Addendum # 2

Date: August 26, 2015

PROJECT #: NT-0014-C03
Garfield James Madison Elementary School
Garfield Public Schools

DESCRIPTION: Addendum # 2

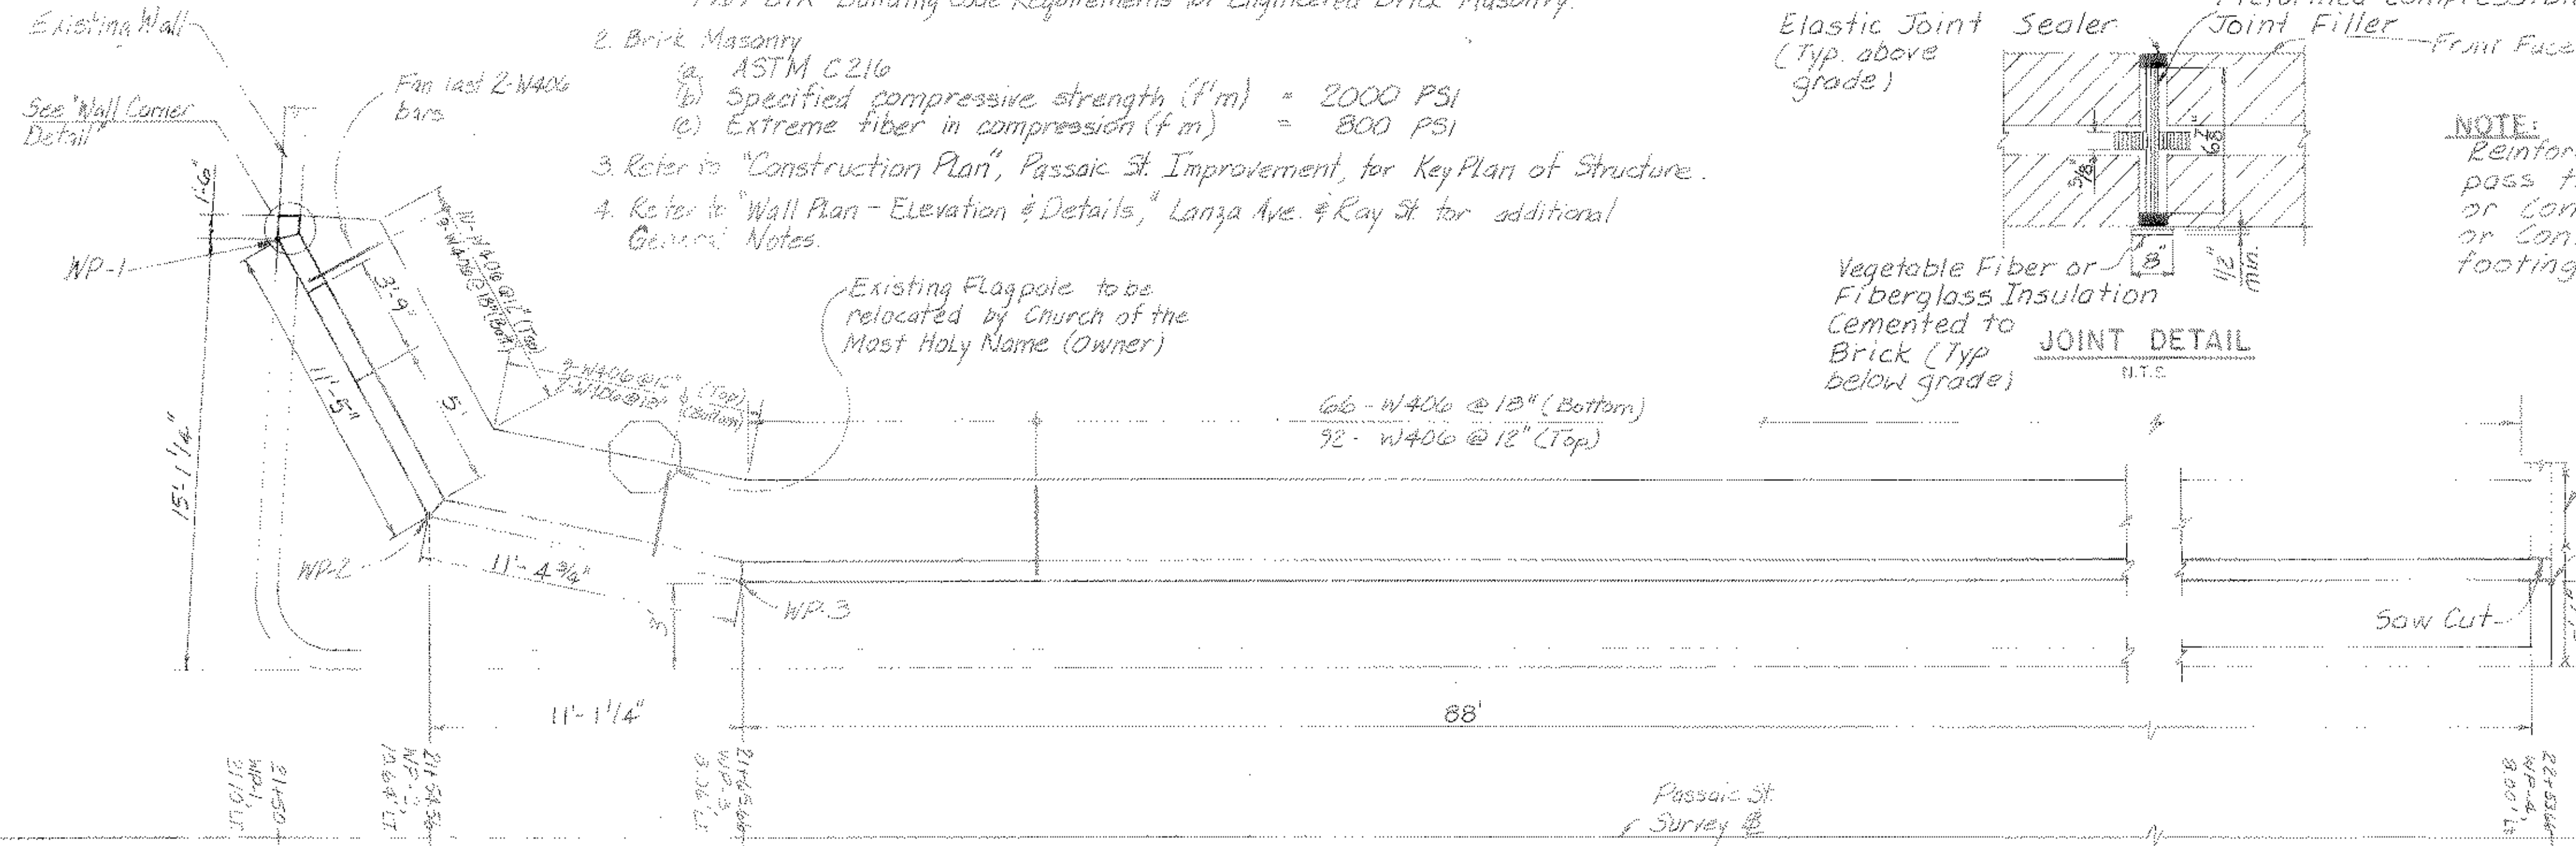
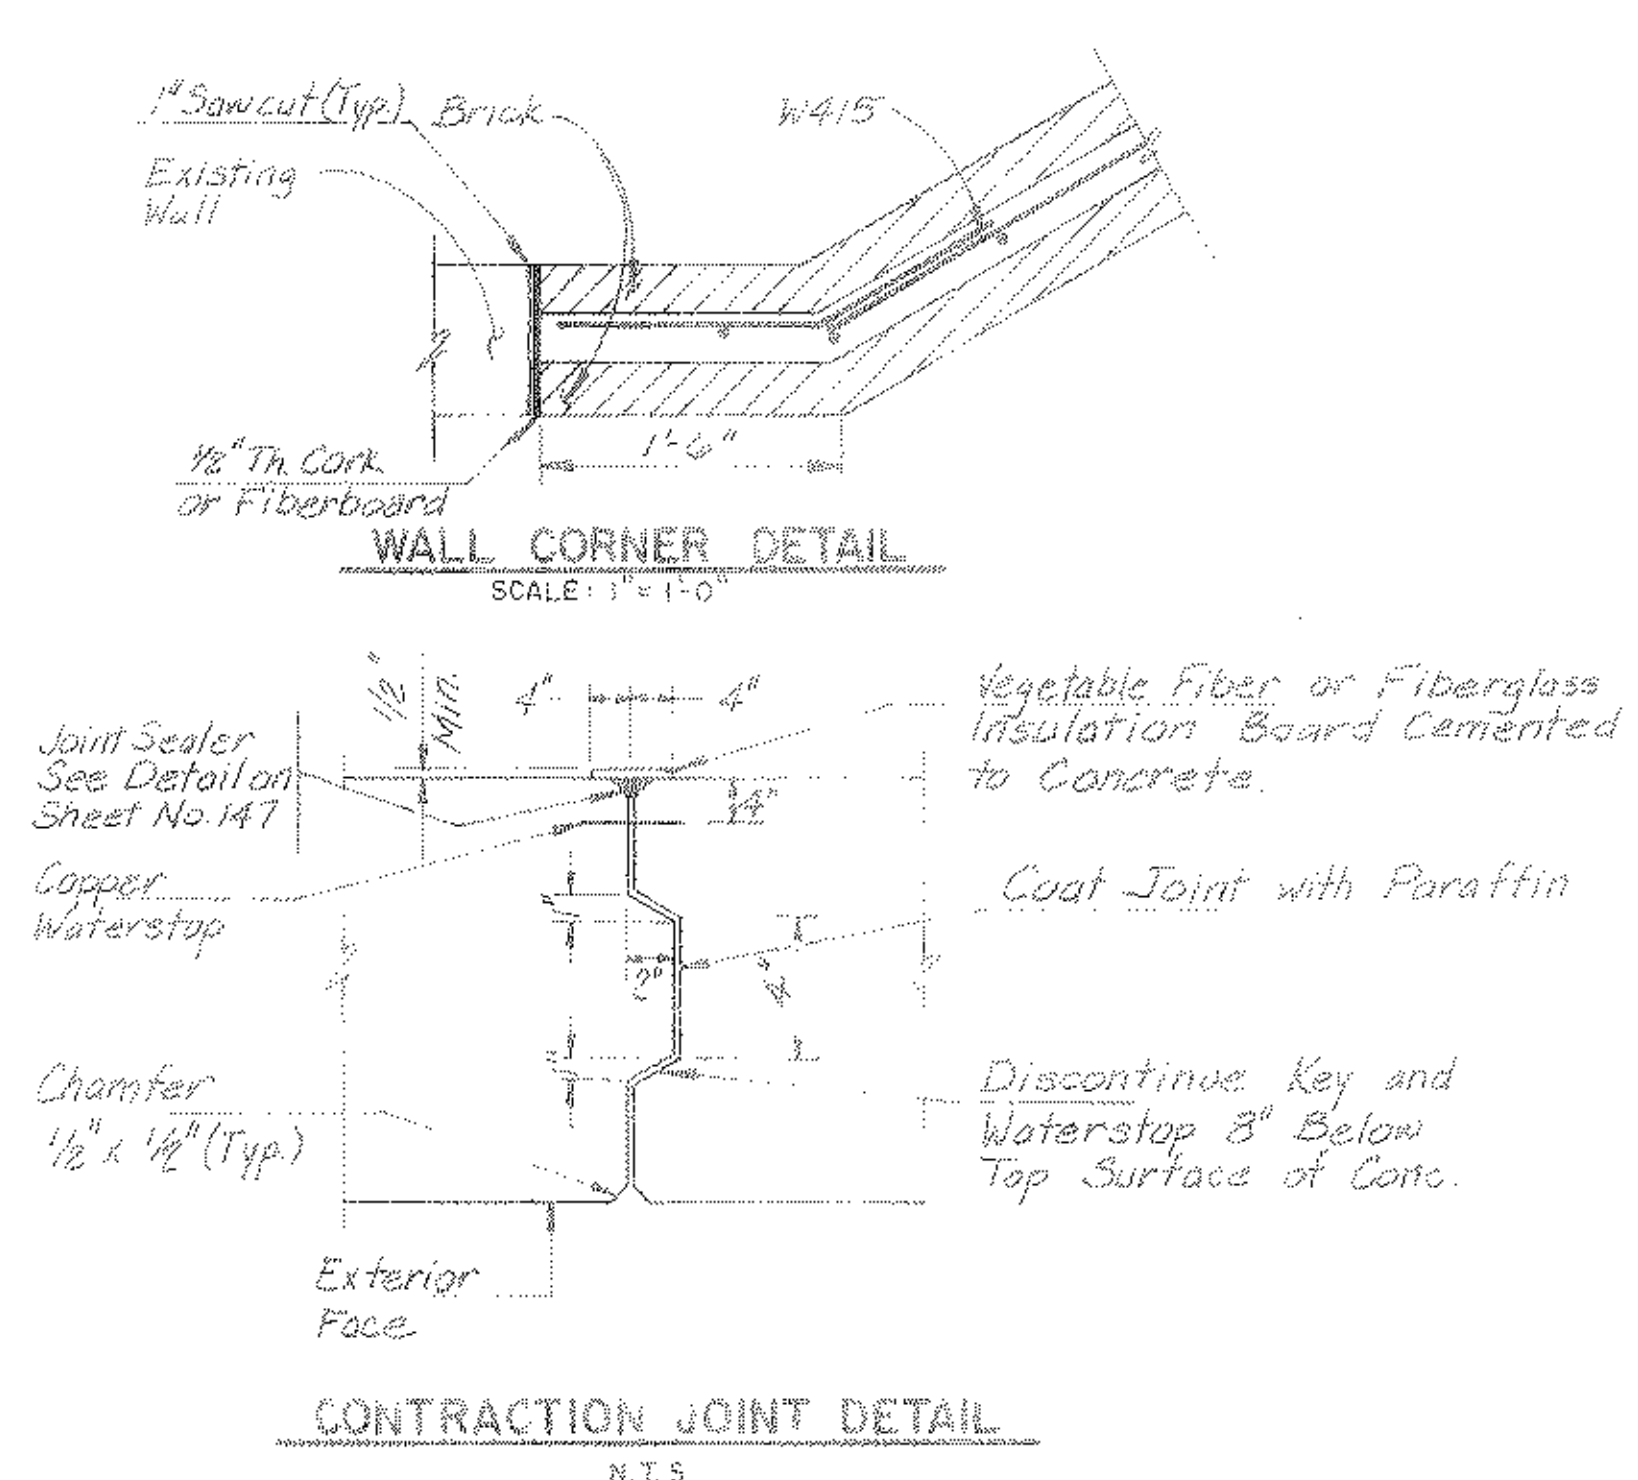
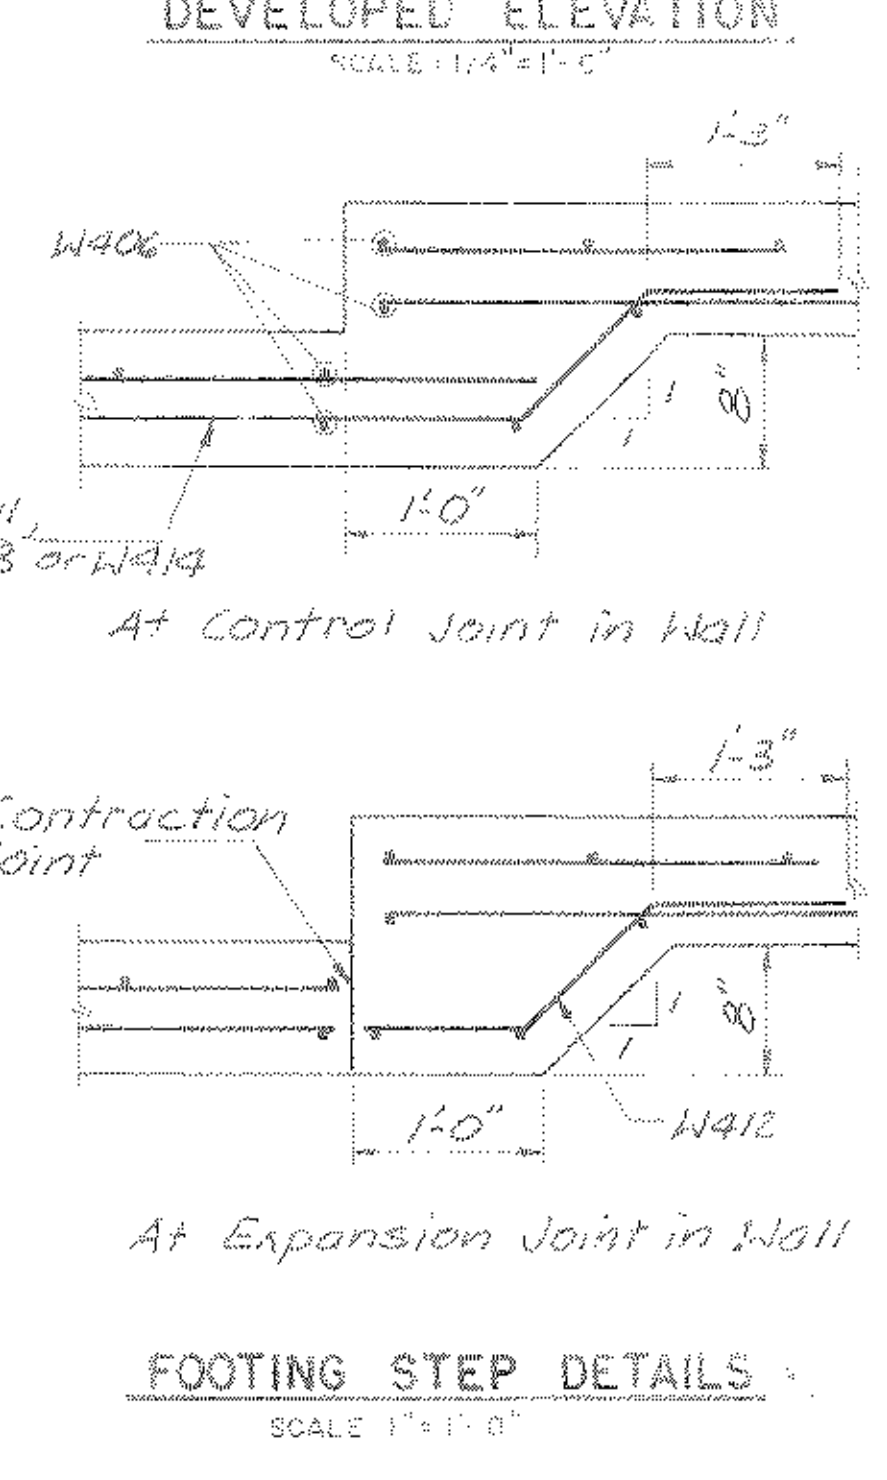
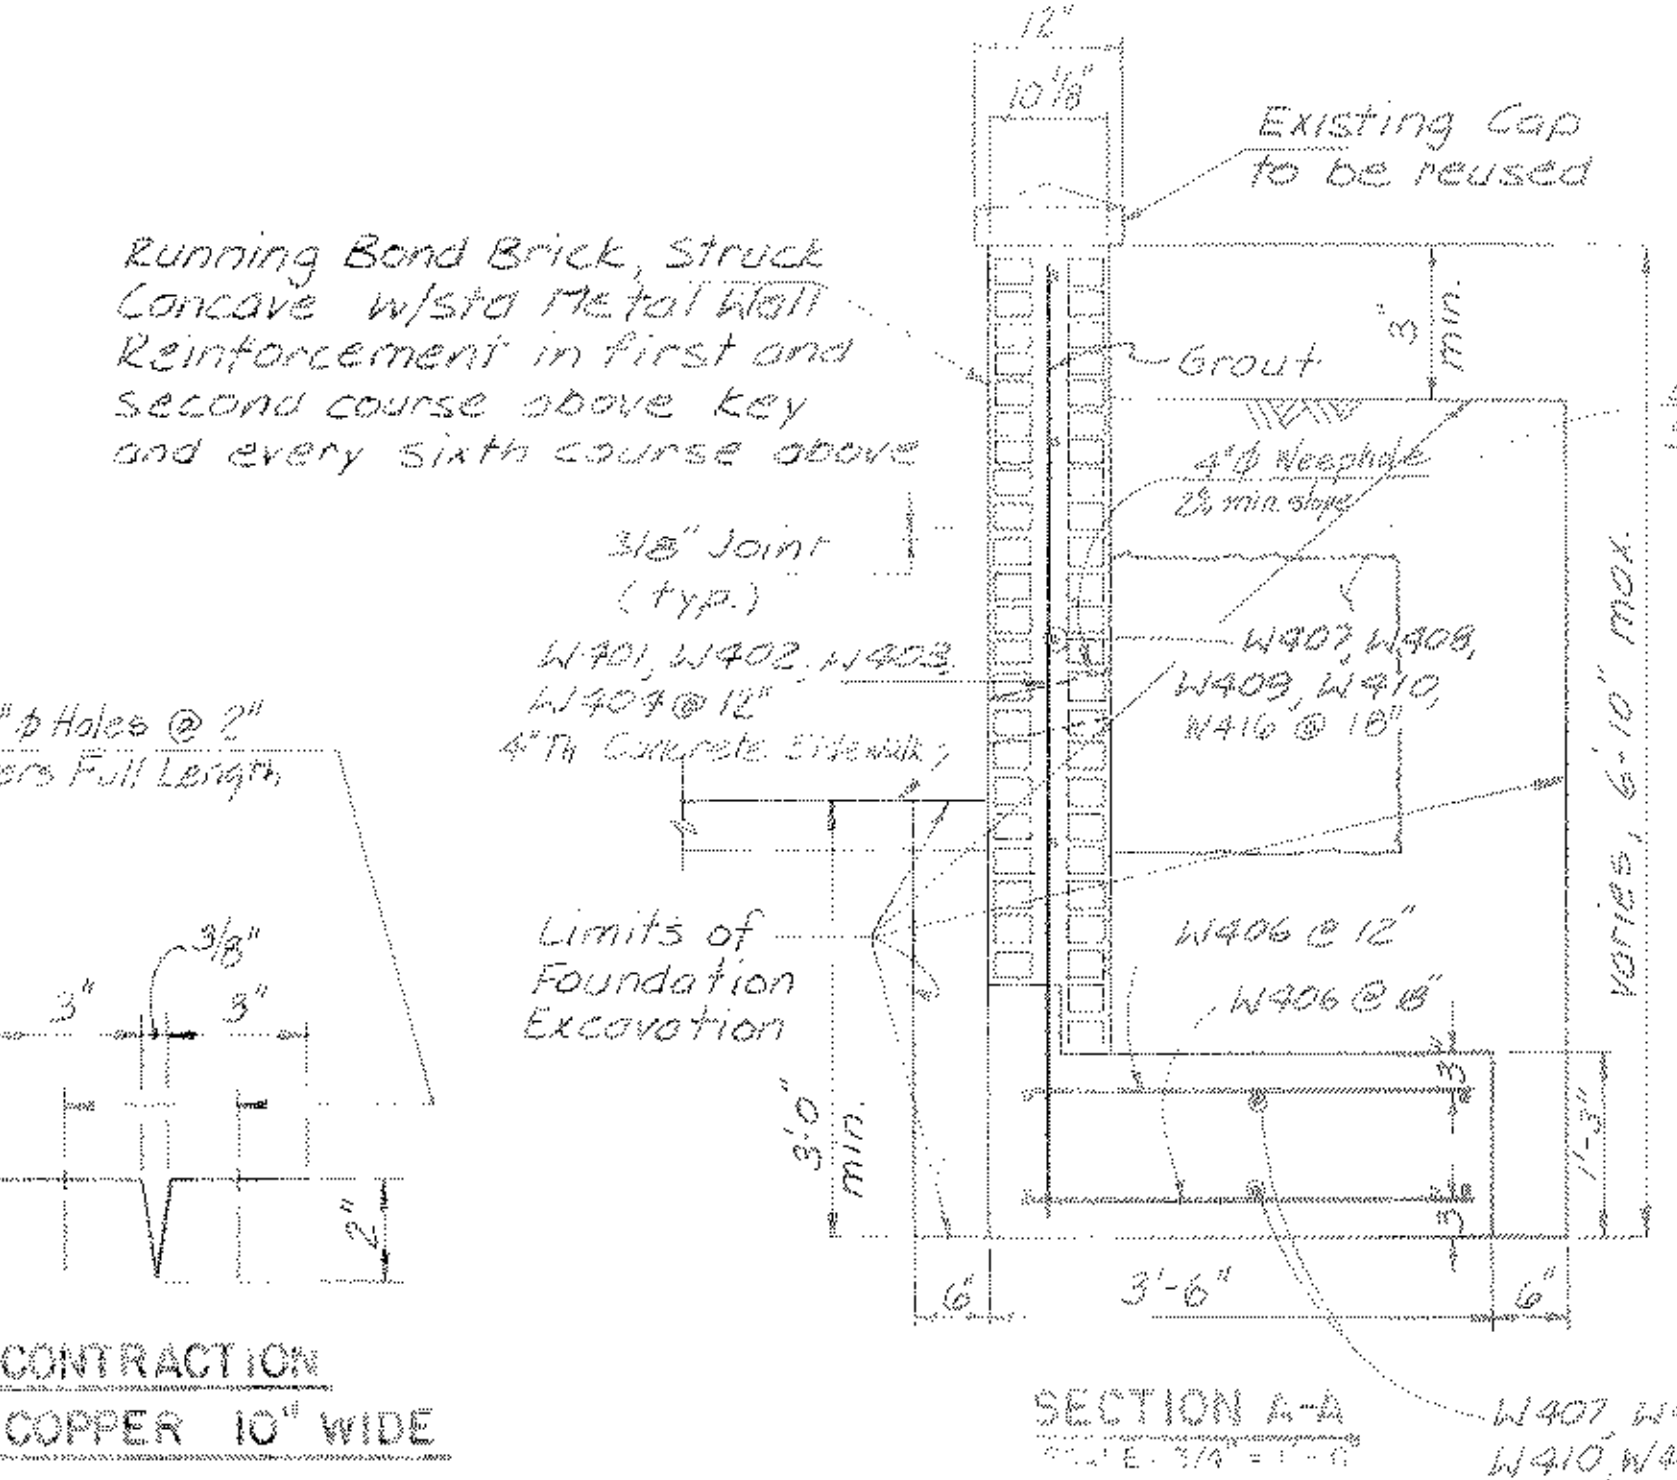
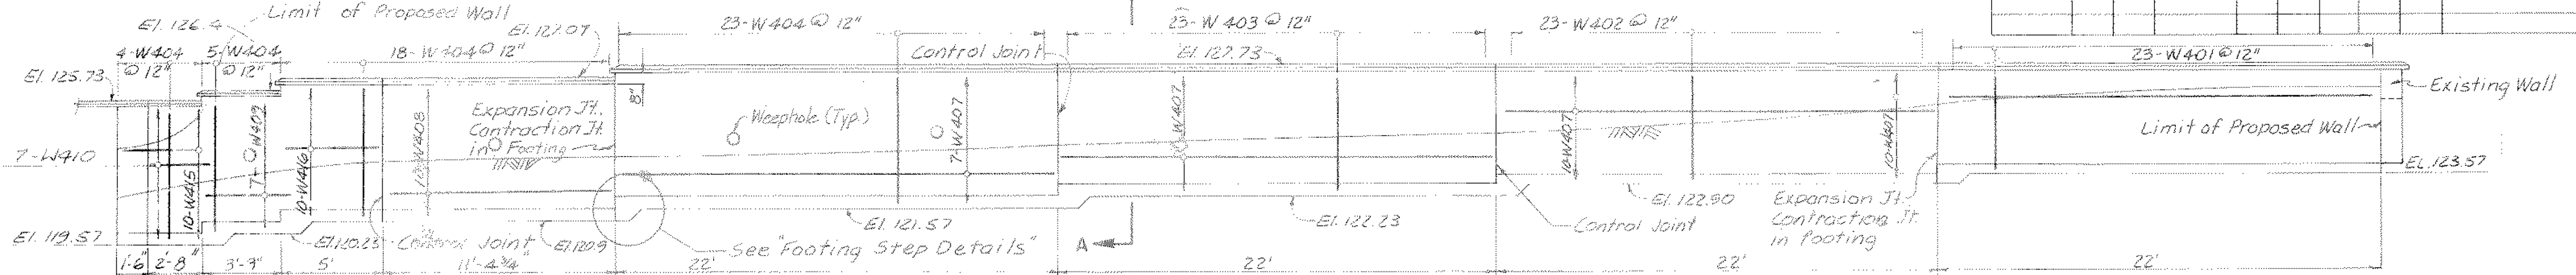
41. Question: Please provide details on the existing masonry retaining wall foundations need to be demolished along Marsellus place and Passaic Street.

- Answer: Refer to Drawing Nos: 26/152, 27/152, 72/152, 73/152 and 137/152, as prepared by RBA for the New Jersey Department of Transportation – Passaic Street Improvement, dated 6/27/85, included with this Addendum as Attachment(s) 2.1, 2.2, 2.3, 2.4, and 2.5. In estimating their bids for removal and disposal of existing masonry retaining wall footings and foundations, Contractors should assume the existence of 25% more underground foundation material than is currently shown on the above drawings

Drawing Number
AD1-SK1

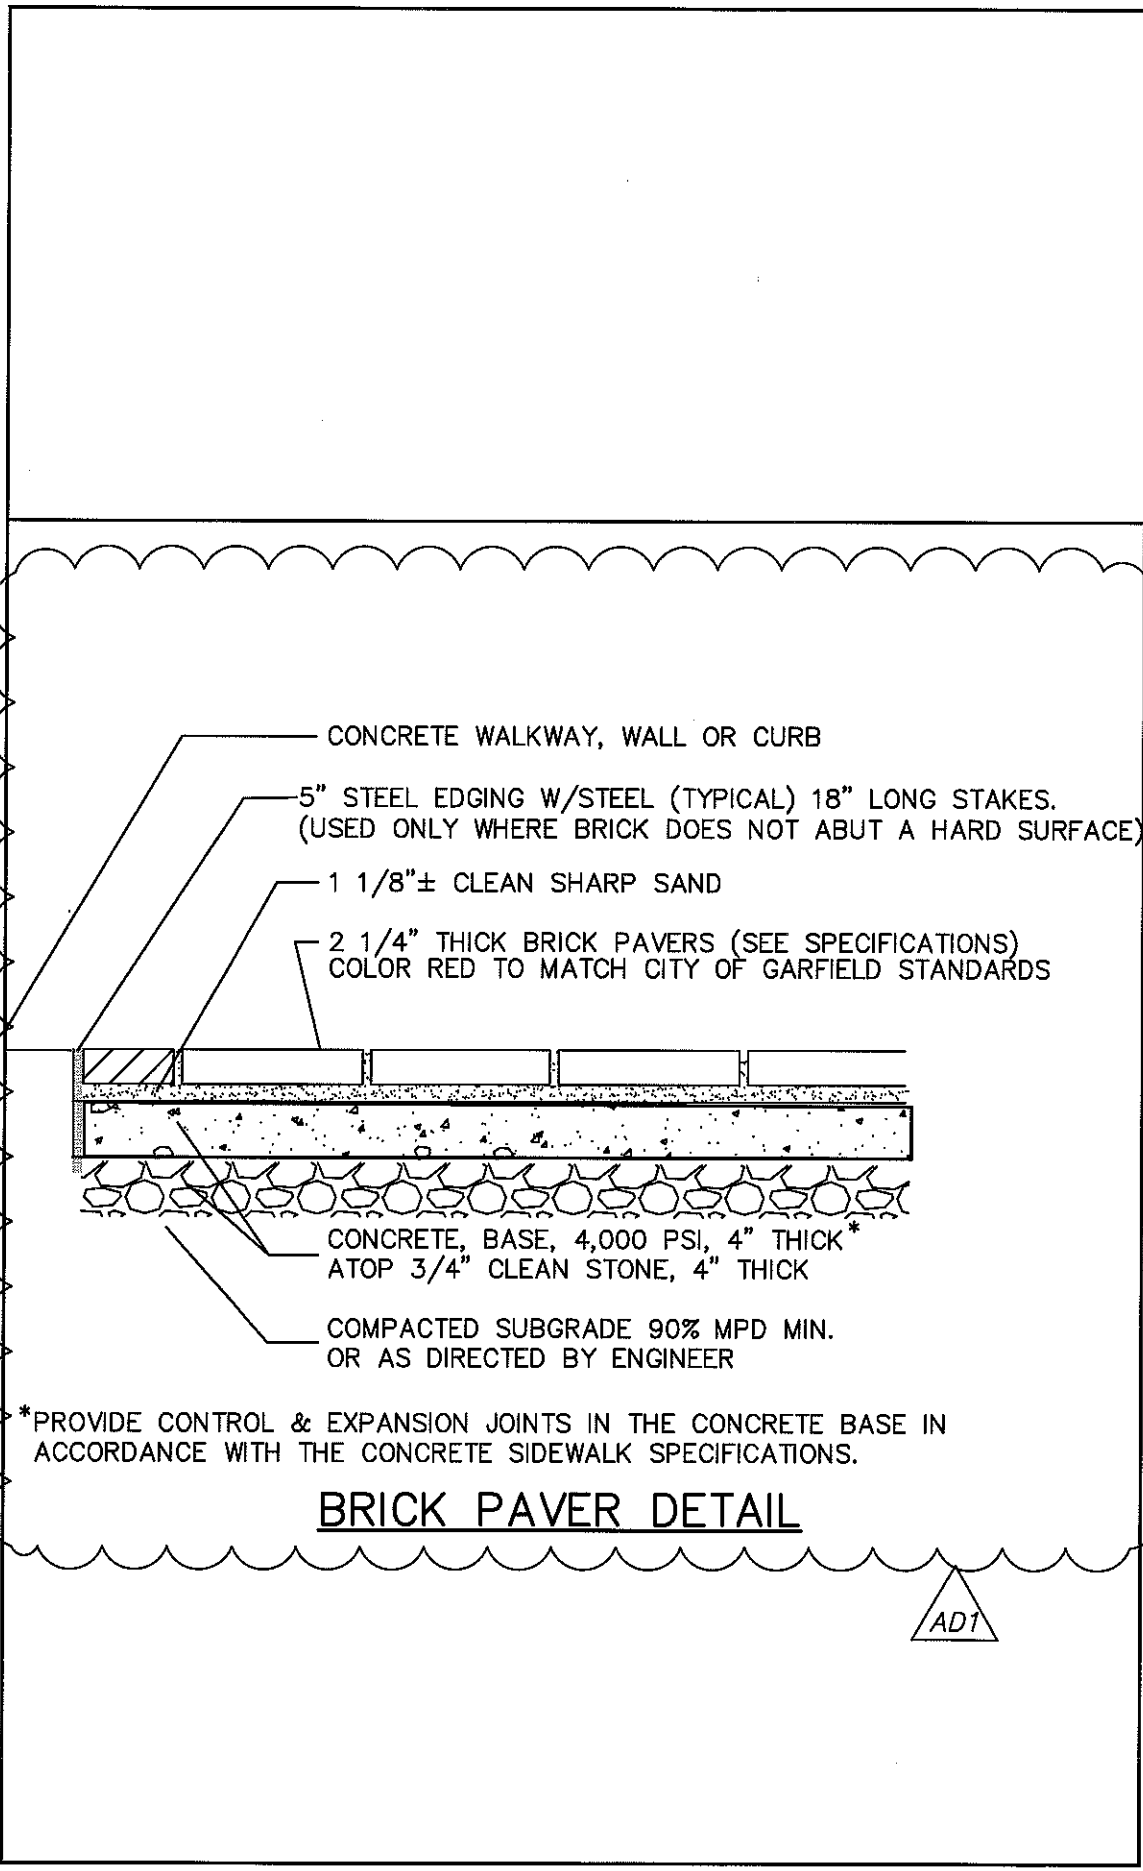
1. **ADD:** Sketch AD1-SK1, inadvertently omitted from Addendum 1, is included with this Addendum as Attachment 2.6.
2. **MODIFY:** In Drawing SW-107 ("Soil Erosion and Sediment Control Plan") the Notes regarding "Safety Barrier or Sidewalk Closure" shall be changed from "~~SAFETY BARRIER OR SIDEWALK CLOSURE (SEE LEGEND)~~", to read "SAFETY BARRIER (SEE LEGEND AND NOTES ON SW-101)". All other plans, sections and elevations are modified accordingly by implication.

13. Question: Provide missing sketch AD1-SK1 from addendum # 1 for above reference project.

Answer: Sketch AD1-SK1, inadvertently omitted from Addendum 1, is included with this Addendum 2 as Attachment 2.6.
